Re: Saguache County Landfill EDOP Modification – Final Cover Design
Saguache County Landfill
Saguache, Colorado
SW/SAG/SAG 2.2

Saguache County Landfill
Engineering Design and Operations Plan (EDOP) Modification

Attachment 1
Construction Drawings for Final Cover Redesign

Sheet 1 of 4

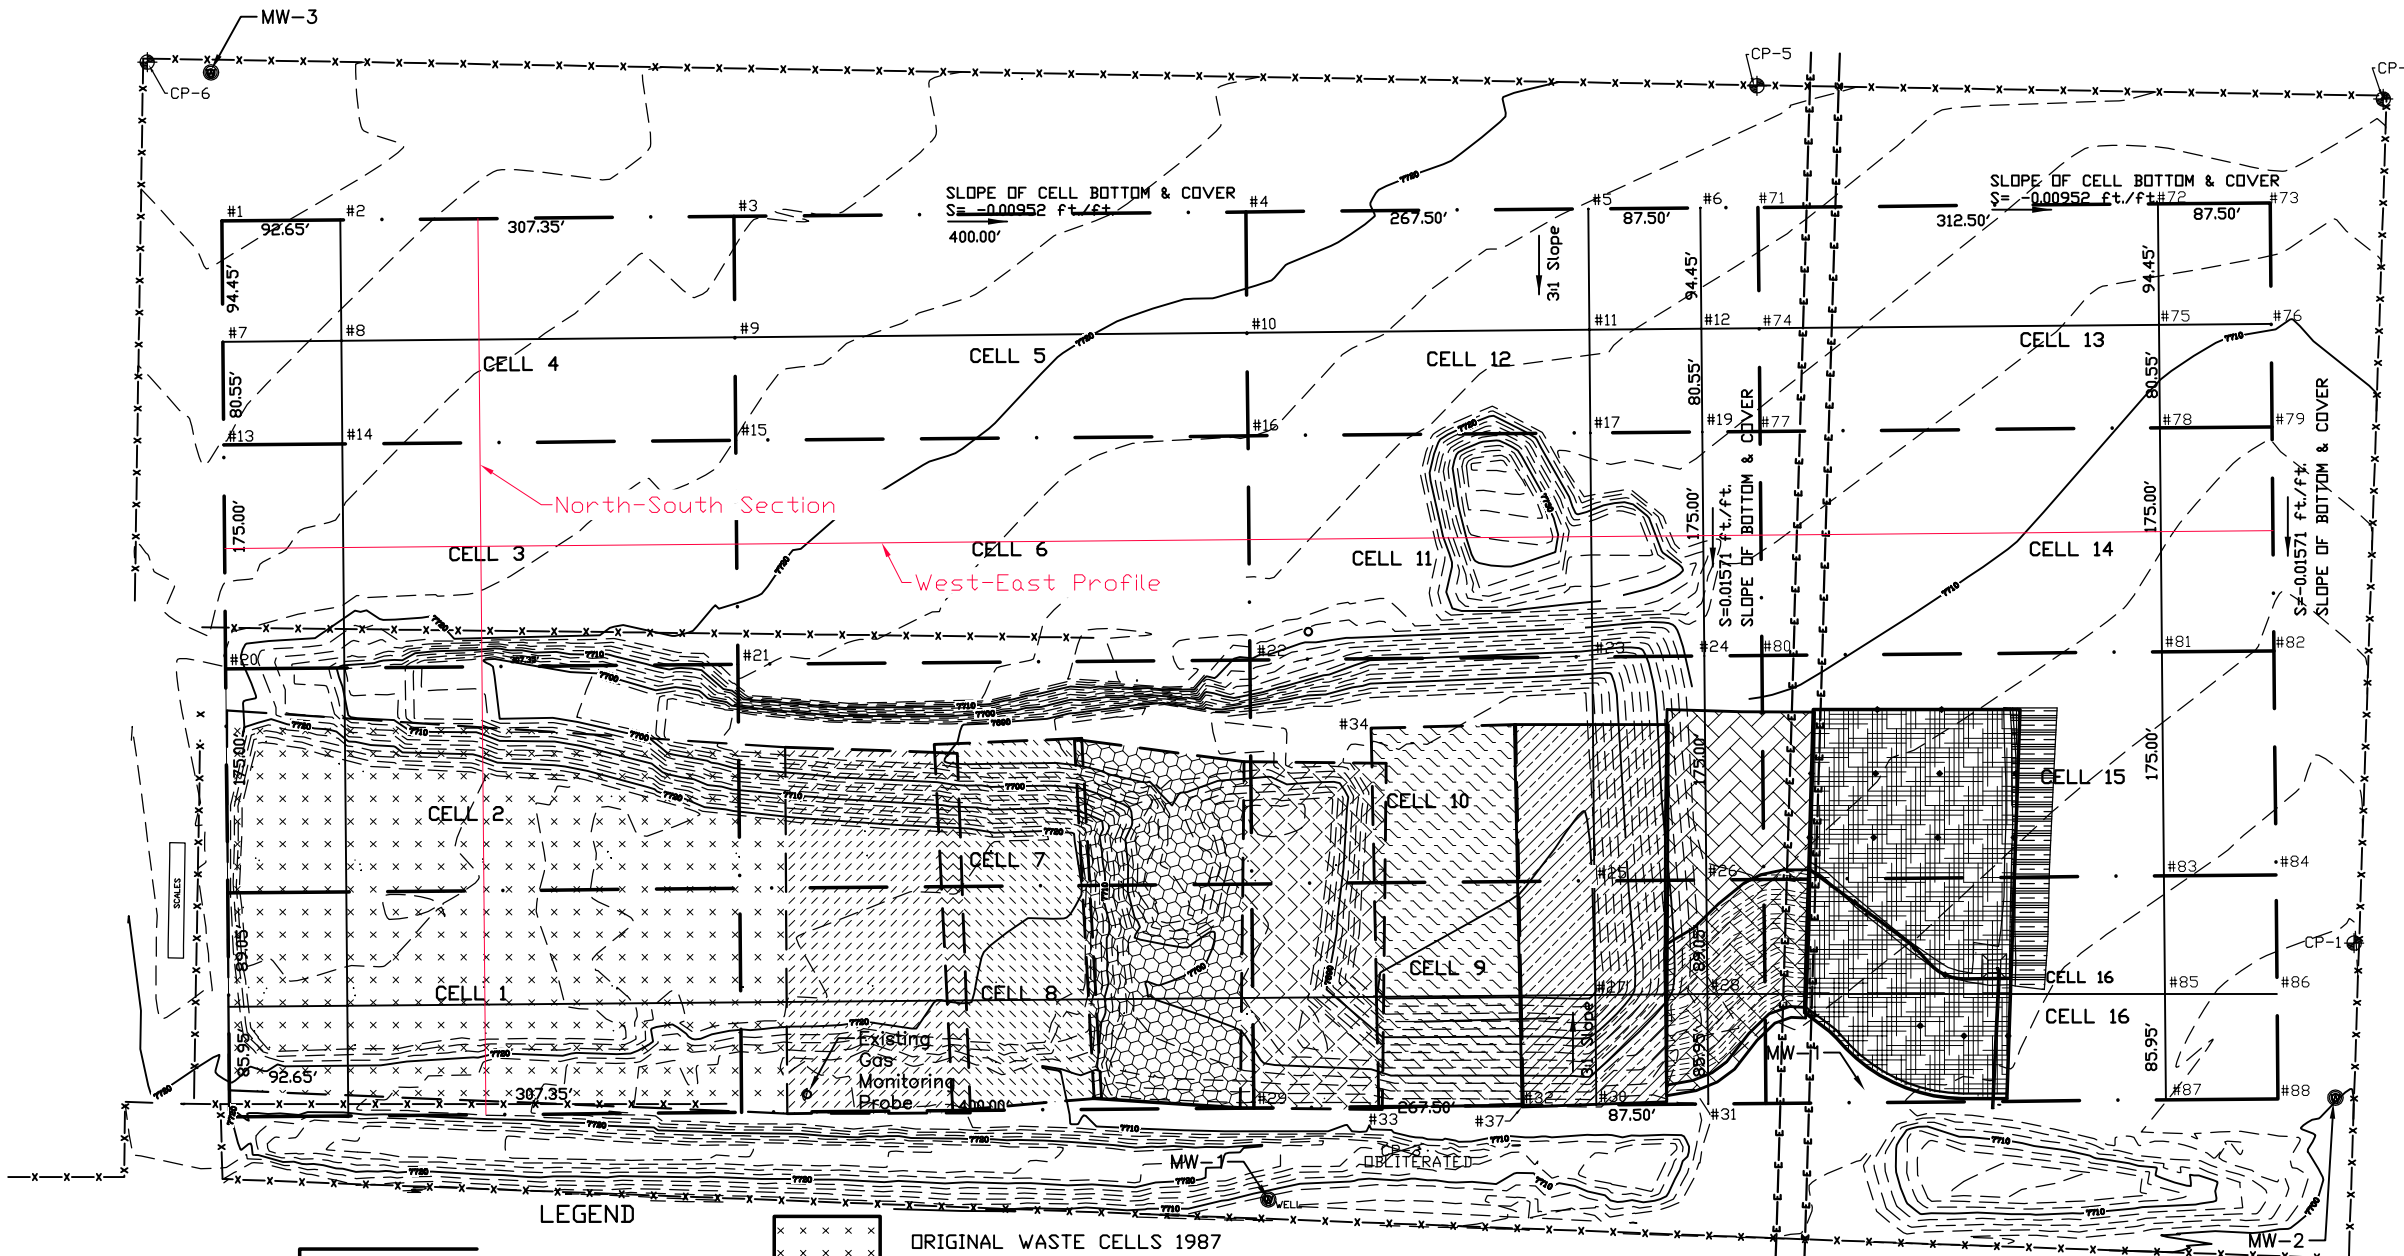
Comment #2: Attachment 1 (Construction Drawings for final Cover Redesign) includes a plan view of the landfill identifying waste cell locations. Waste cells appear to be identified by the year the construction of the extensions were completed. Each waste cell extension is prefaced by the term "Liner" suggesting each waste cell has an engineered lining system constructed in accordance with the Engineering Design and Operations Plan (EDOP) in effect at the time of construction. As discovered in 2011 not all cells were appropriately constructed resulting in unlined waste cells. Update the referenced figure to appropriately identify unlined cells.

Sheet 1 of 4 of has been revised, please see Attachment #1. Rather than "Liner" each yearly expansion is labeled as "Waste Cell Extension".

Since year 2000 constructed cell extensions contain as a minimum a Geosynthetic Clay Liner (GCL) which, in the County's opinion should not be categorized as "Unlined" cells. Each cell extension may not consist of all liner components required by the approved EDOP at that time, but it does consist of at least a GCL. Furthermore, the correspondence in our file is somewhat confusing and seemed to indicate the installation of the GCL was adequate. Also, the County has some evidence that would support an assumption that the "Original Waste Cells" constructed during years 1987 through 1990 were lined with clay as required in the first EDOP. Therefore, in the County's opinion all constructed cell extensions are "Lined" although it is now recognized that a portion of the liners may be of an unapproved design. The County would like to make it clear that any further cell extension will follow the current approved EDOP and a double liner system will be installed.

Sheet 2 of 4

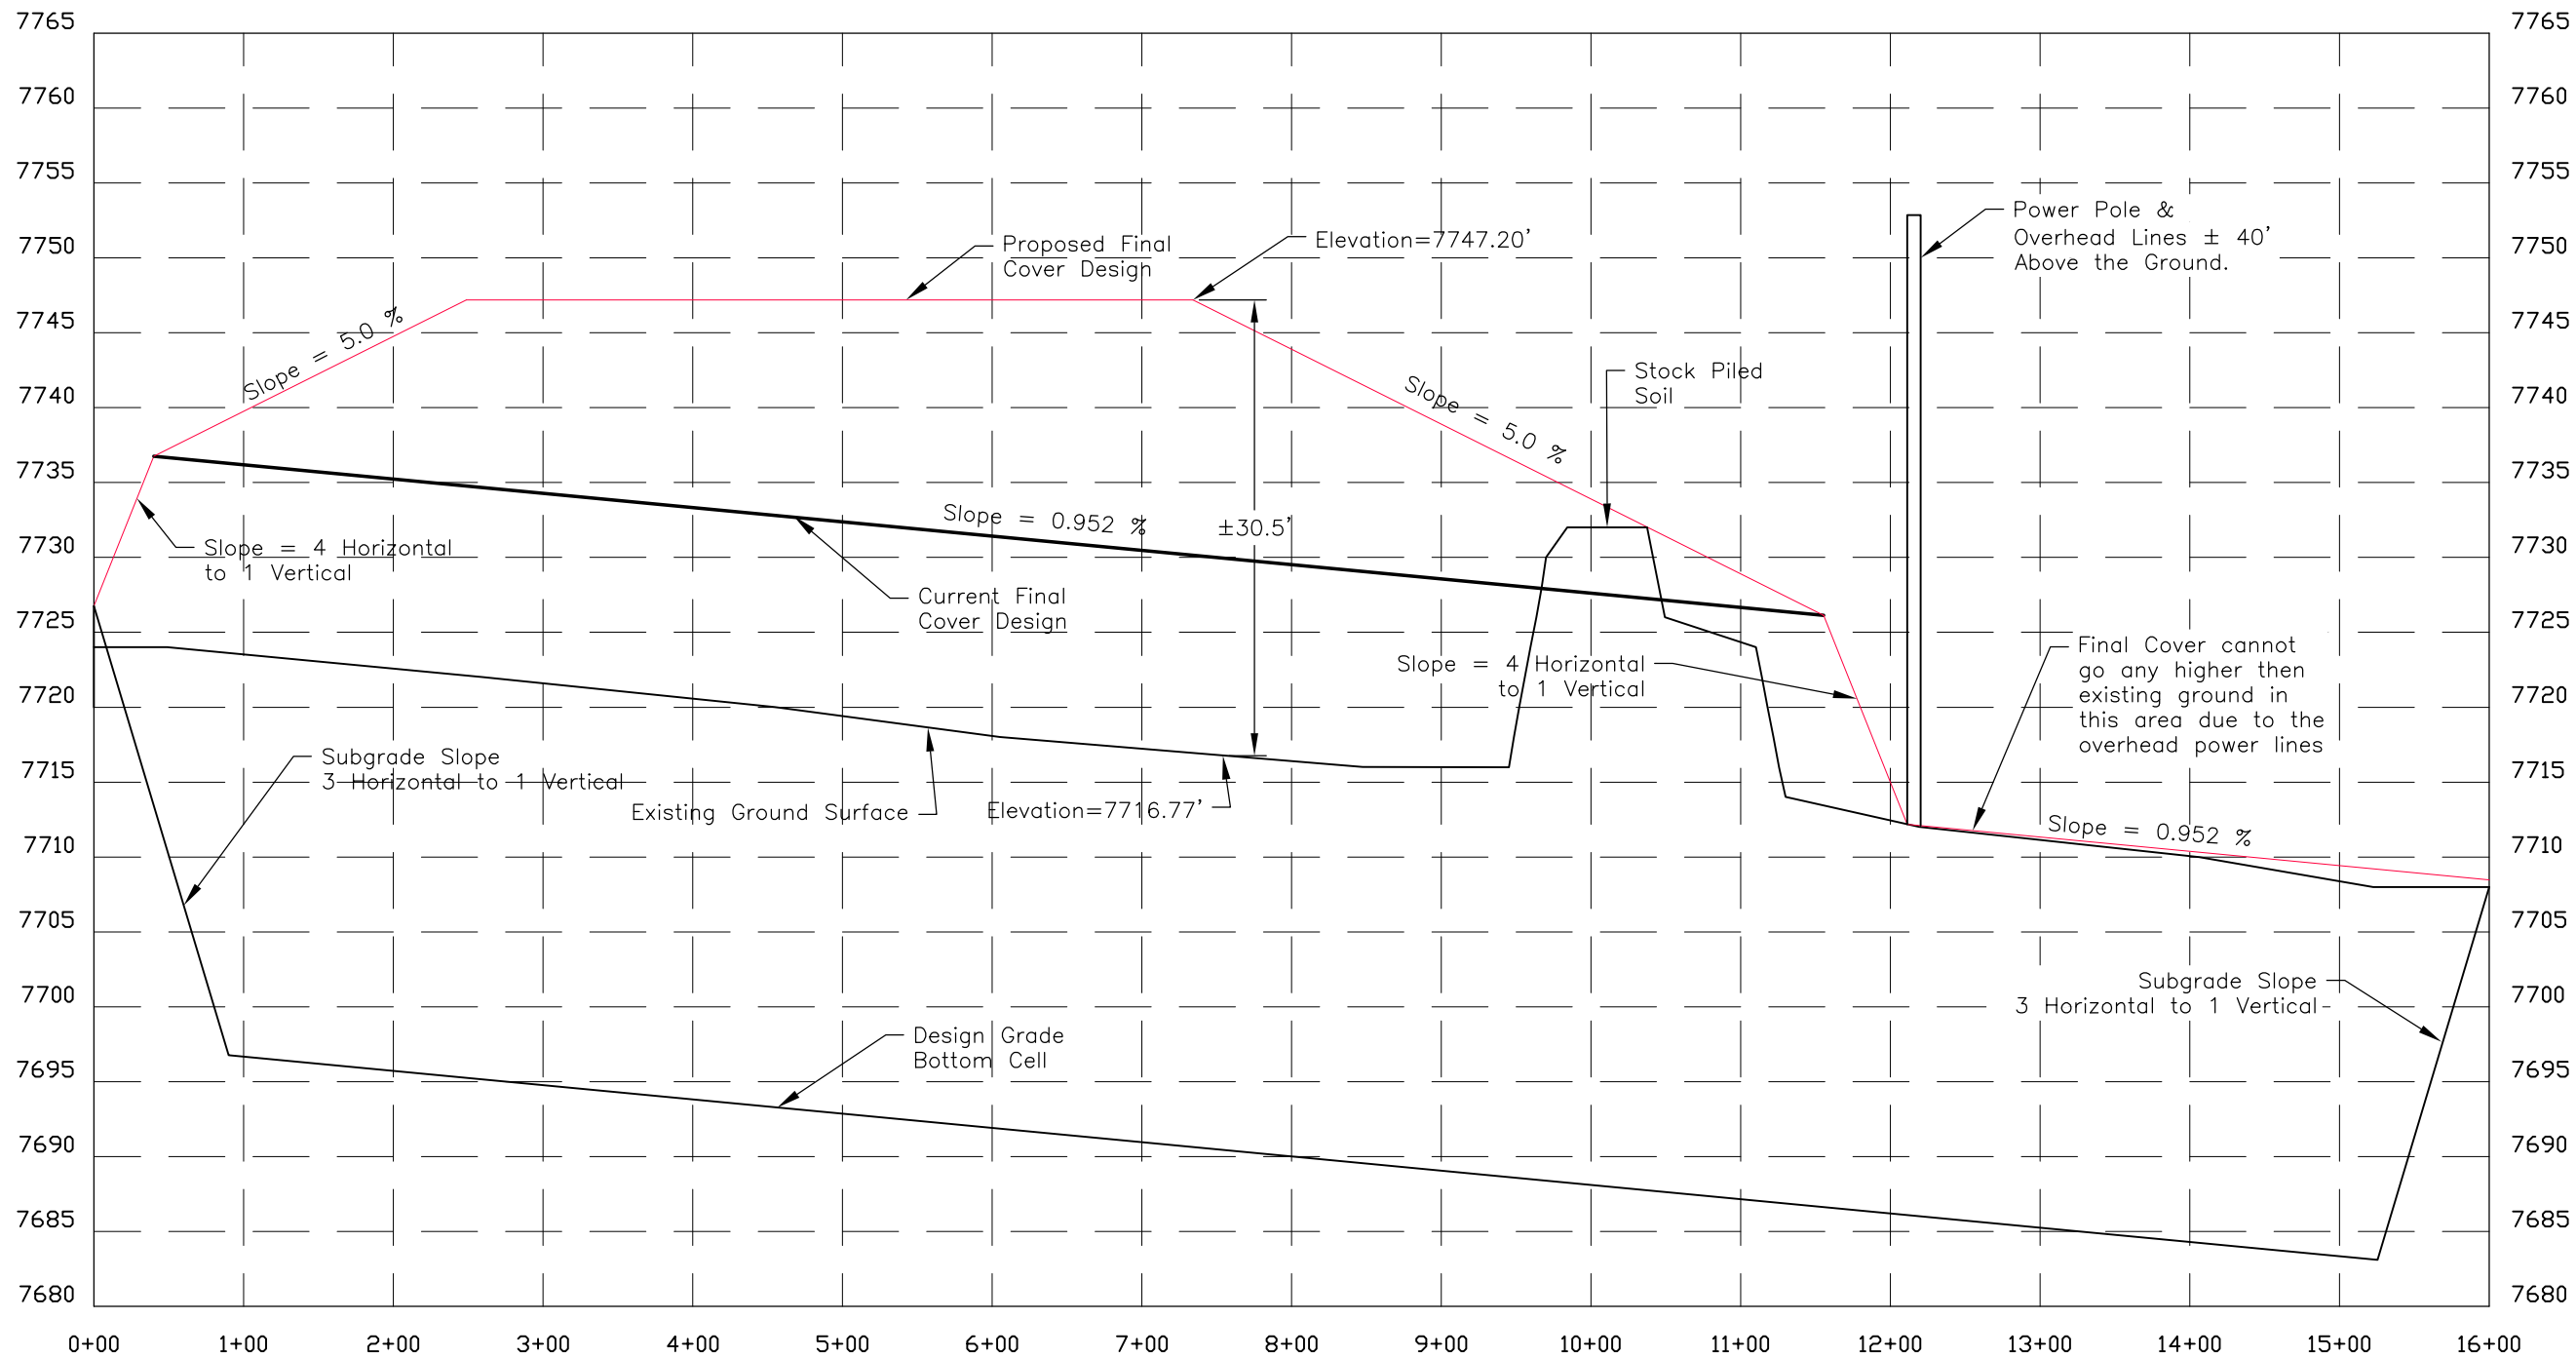
Comment #5: The EDOP Mod states that "…with the proposed final cover changes there will not be any slopes under 5%". Attachment 3 of the EDOP Mod addresses RUSLE erosion calculations. Table 1 associated with these RUSLE calculations indicates the easterly slope has a portion with a 0.2% slope (see Slope 3). Please address this apparent discrepancy and recalculate the erosion calculations as necessary.

As you have pointed out the easterly slope erosion calculation does include a portion of the slope which is 0.2%. This is correct because the easterly end of the landfill cap cannot be higher than the existing ground surface due to the power transmission lines in this area. So no recalculation is needed.
